— STANDARD 12-TON WAGON. —

— Modification of bottom half of Oil Axlebox —  
— Drawing No. 1019. —

— D<sup>G</sup> N<sup>O</sup> 1030. —

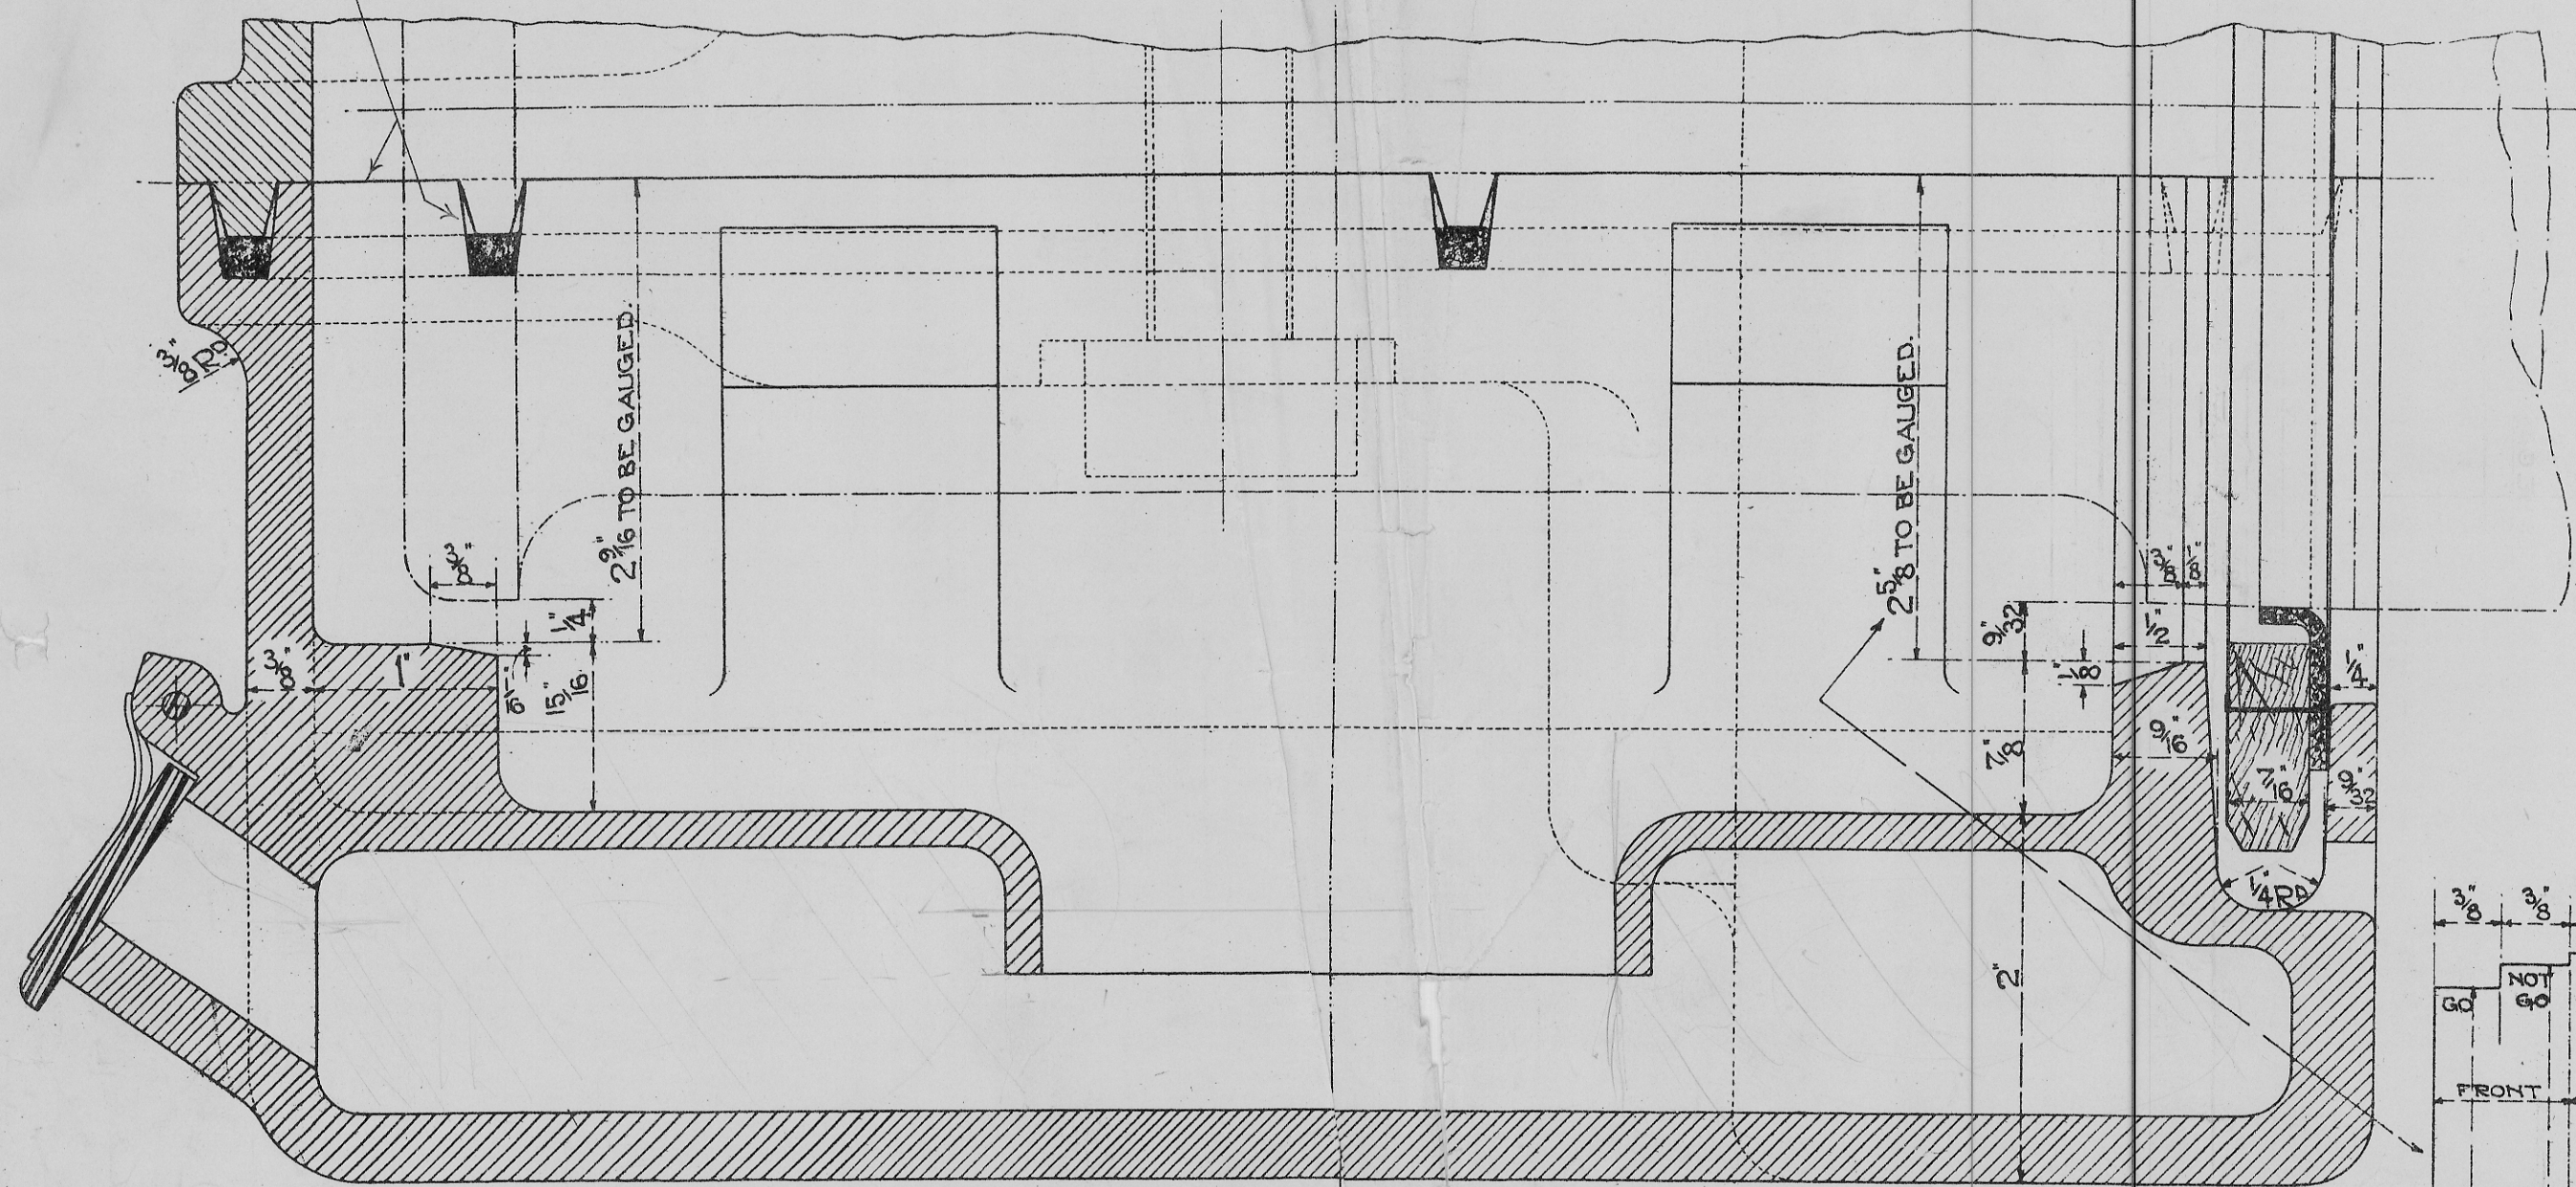
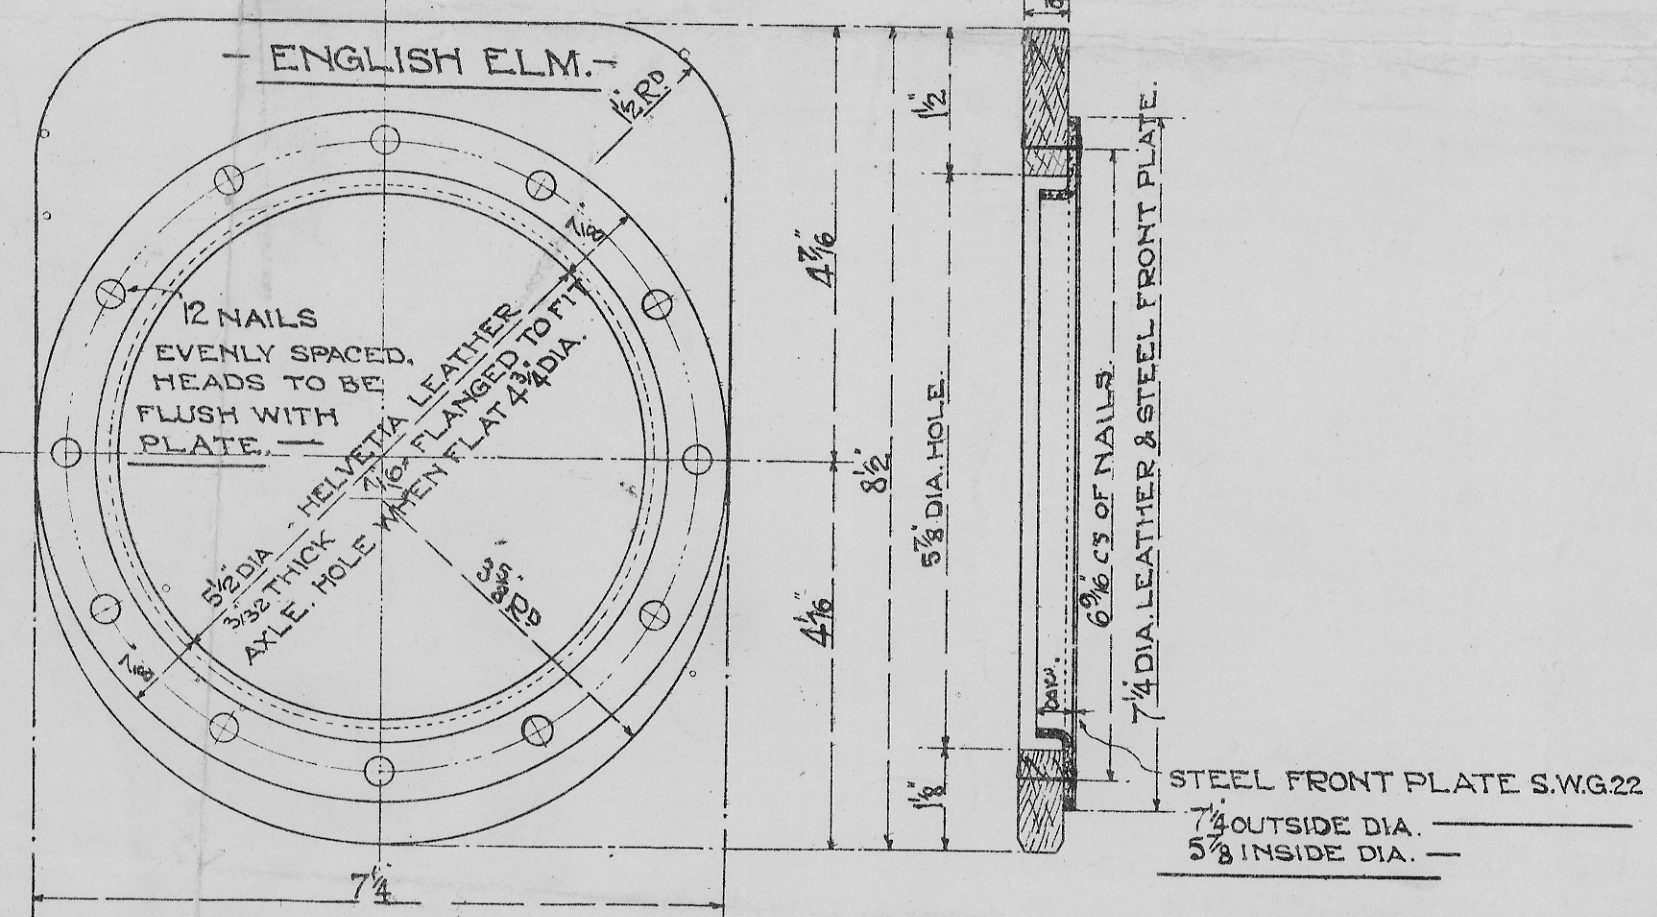
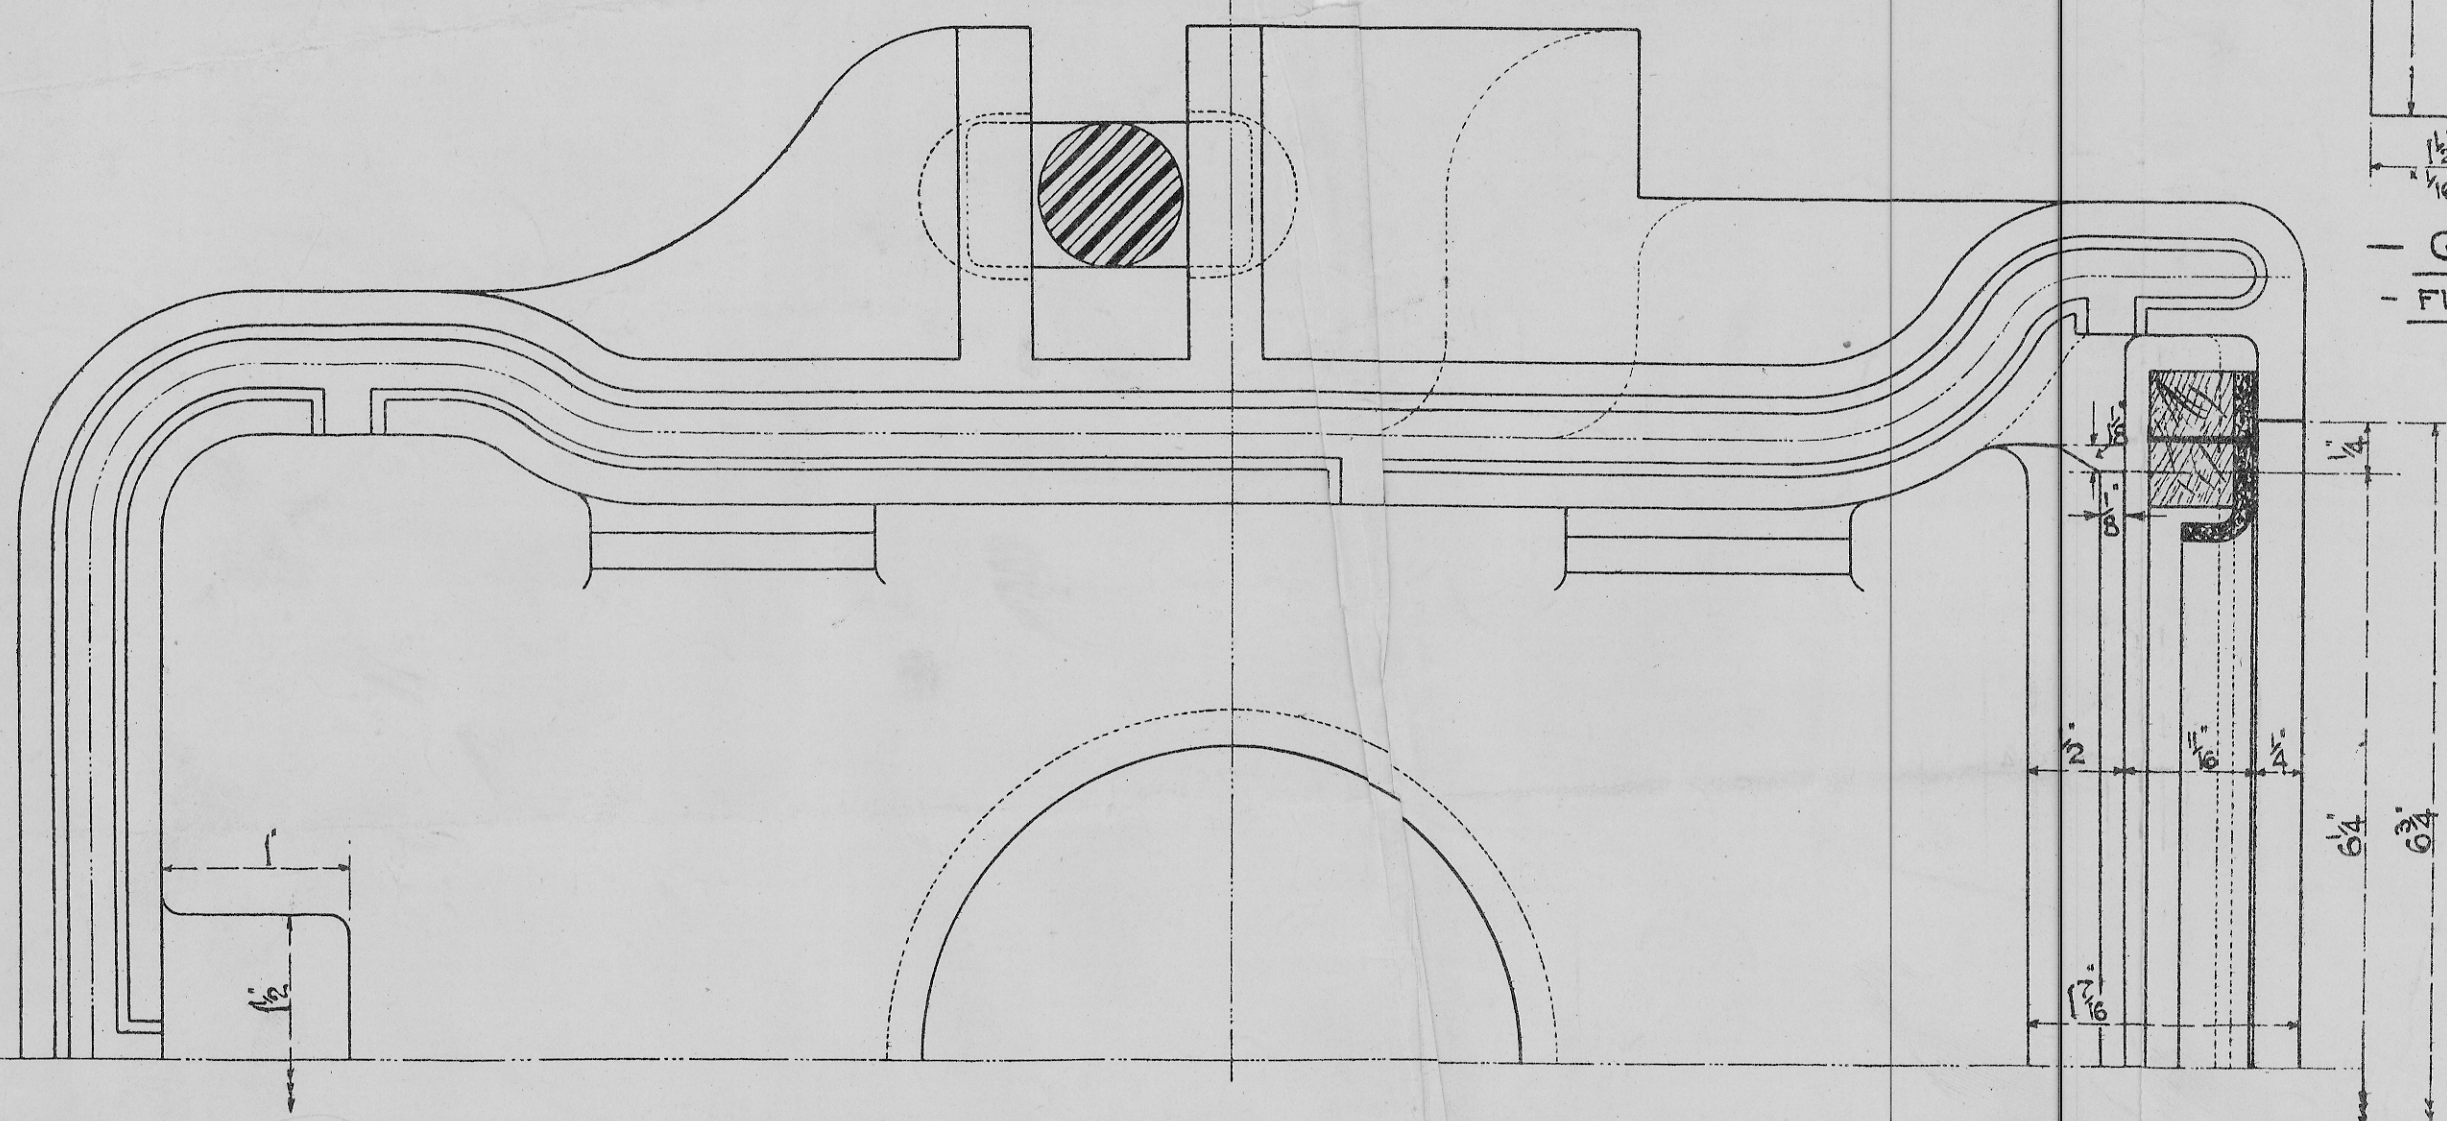
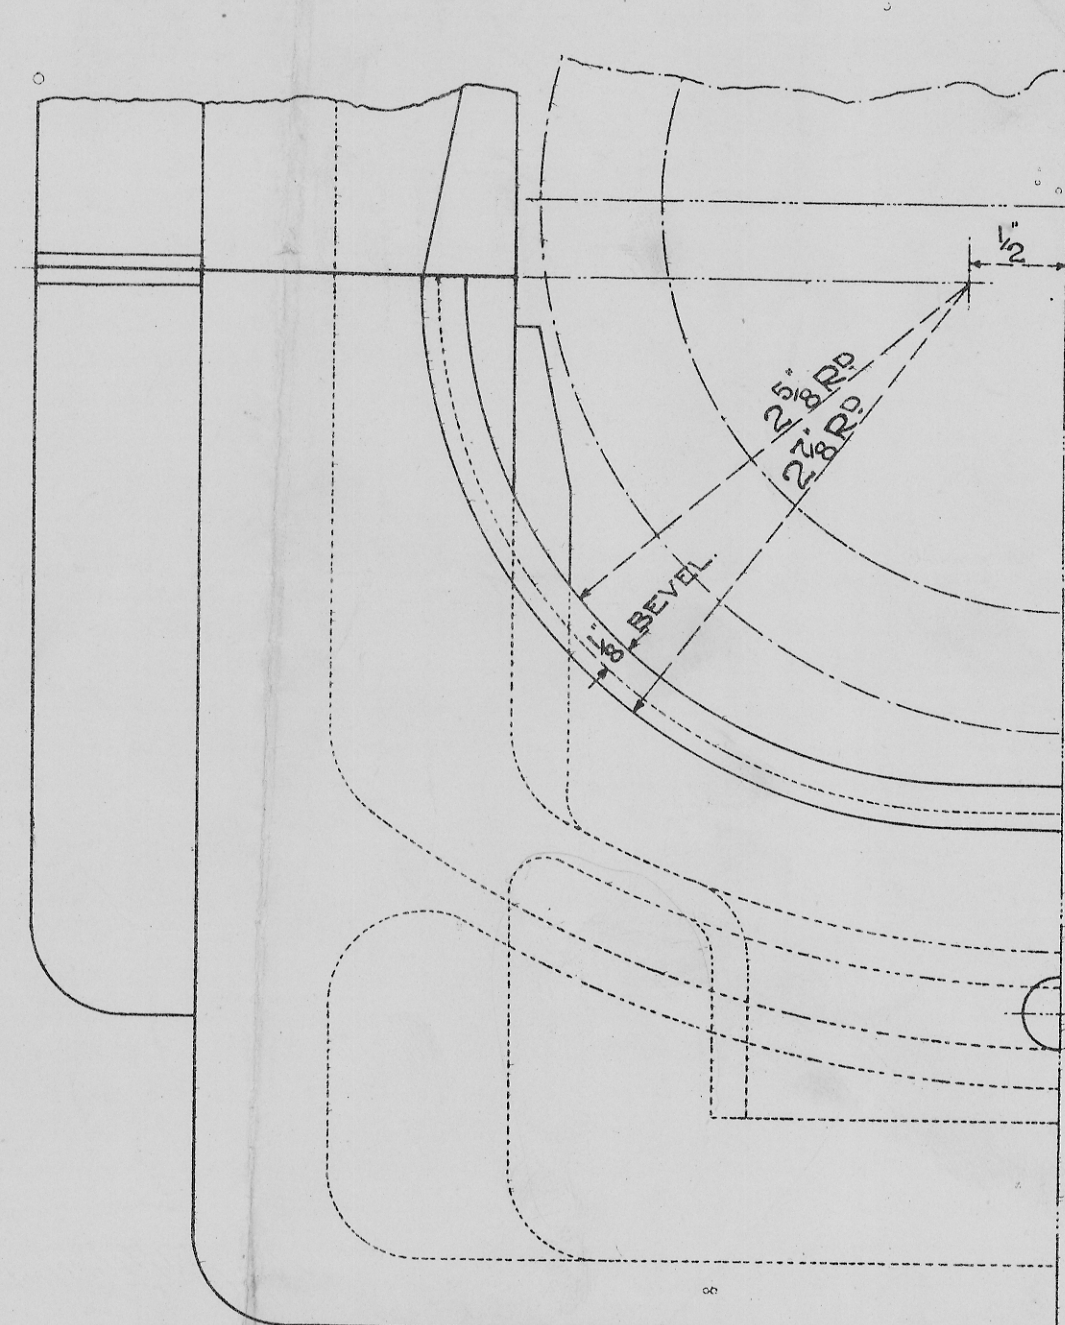
NOTE.—This bottom is interchangeable with that shown on Drawing 1019 and must be used on all new boxes and for replacements of existing bottoms when necessary. In the case of renewals, existing steel dust shields may be used (provided the bottom spring of the dust shield is removed), or they may be replaced by the shield shown hereof at Owner's option.

This bottom also interchanges with that shown on Drawing 1022, and may be used in place thereof. A new drawing embodying these alterations and superseding Drawing 1019 will be issued shortly.
